# PLANNING CLEARANCE

Re: **Lot 9, Independence Ranch**  
**CGS Review No. MA-03-0038**

Re: Slope Stability, 2070 Raindance Court, Grand Junction, Colorado

**SLOPE STABILITY REVIEW**  
2070 Raindance Court, Grand Junction, CO.

### SITE LOCATION DIAGRAM

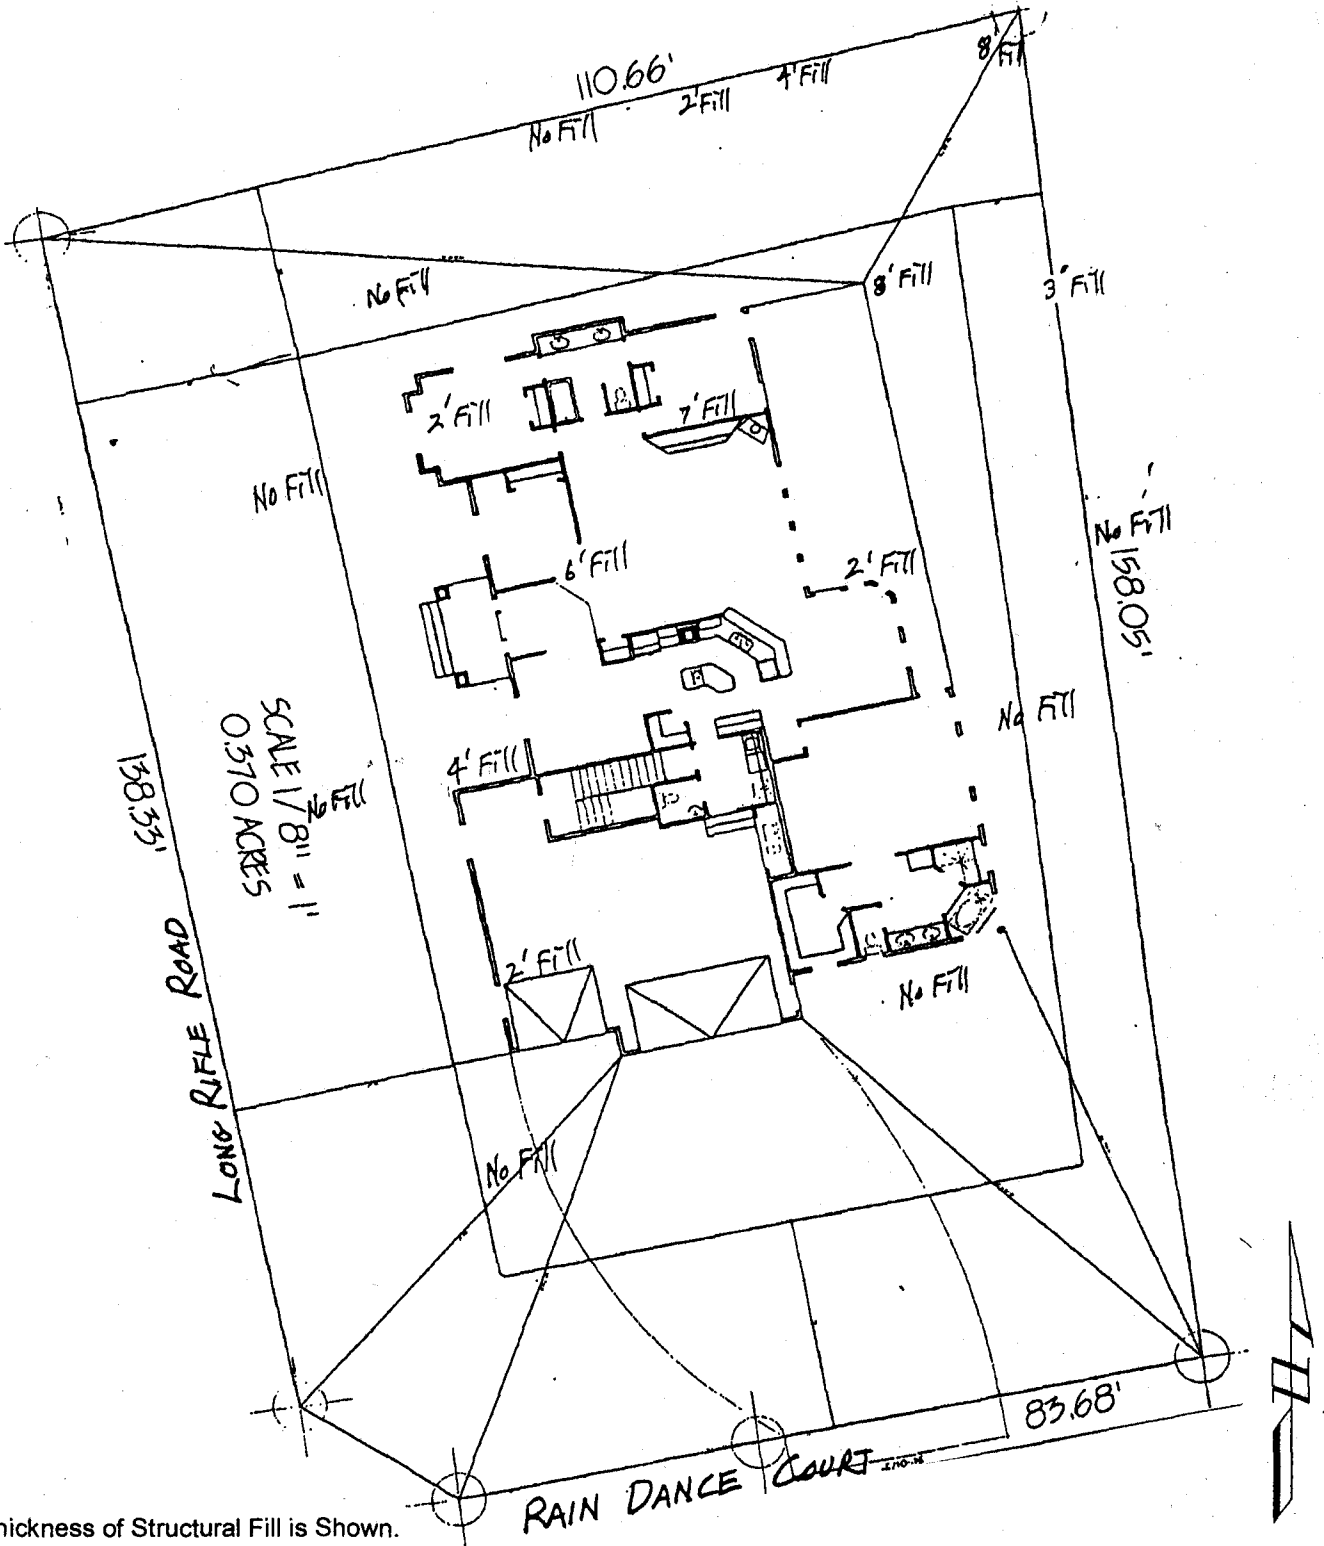
**The site grading has resulted in this lot being removed from the Area of Special Slope Stability Concern.** The subdivision site grading on and adjacent to 2070 Raindance Court has included up to eight feet (8') of controlled fill placed within the old gully. Copies of our Fill Density Test Daily Reports are included with this letter. The controlled fill was placed in conjunction with the storm drainage piping and outlets. The controlled fill was extended over fifty feet (50') to the northeast, with the new gully head at the storm drainage outlets.

The original lot topography included an eight (8') foot deep gully in the north portion of the building area, which drained to the north, northeast, into the gully dissected Bluff Line. The main Bluff Line is over 300' northeast of this building lot. The new site grading has a very gentle slope (1:18, vertical:horizontal) to the northeast, for about 21' feet beyond the building lot. At the upper Slope Break, the slope slightly steepens (1:10, vertical:horizontal) for over 40 feet. At the lower slope break, The final slope into the gully steepens (1:3, vertical:horizontal) for a final slope height of about 8' to 10'. The final structural and controlled fills are mostly founded on the lower sandy Gravel and Cobble.

Thickness of Structural Fill is Shown.

Based Upon GJLD Records and Cut/Fill Mapping.

**GENERAL SITE DIAGRAM**

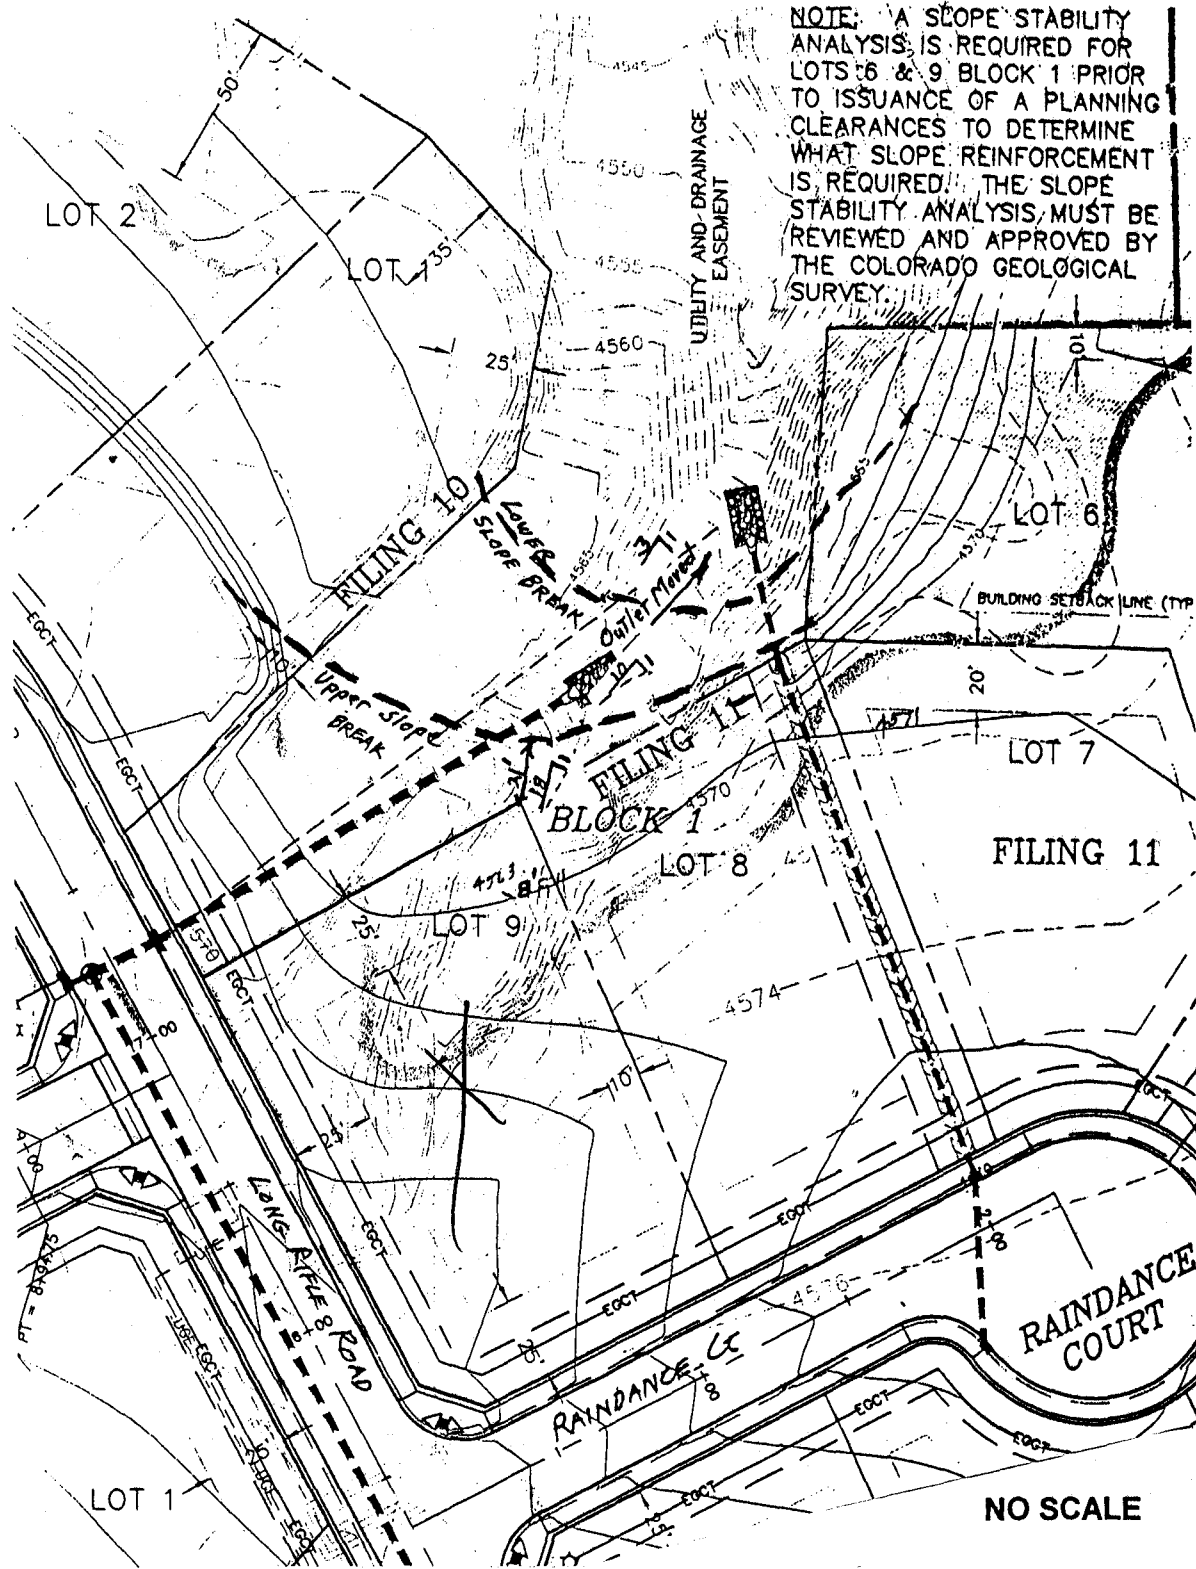
I have reviewed the letter on Slope Stability, 2070 Raindance Court prepared by Grand Junction Lincoln-DeVore (August 5, 2004). The lot, which did have a deep gully extending into the northeast corner, has been filled with up to 8 ft of controlled fill sloped to a very gentle grade. The outlets for storm water are located in the utility and drainage easement and should not affect lot 9 unless headward erosion becomes active.

I find the grading mitigation to be adequate for the site and have no objections to the proposed construction.
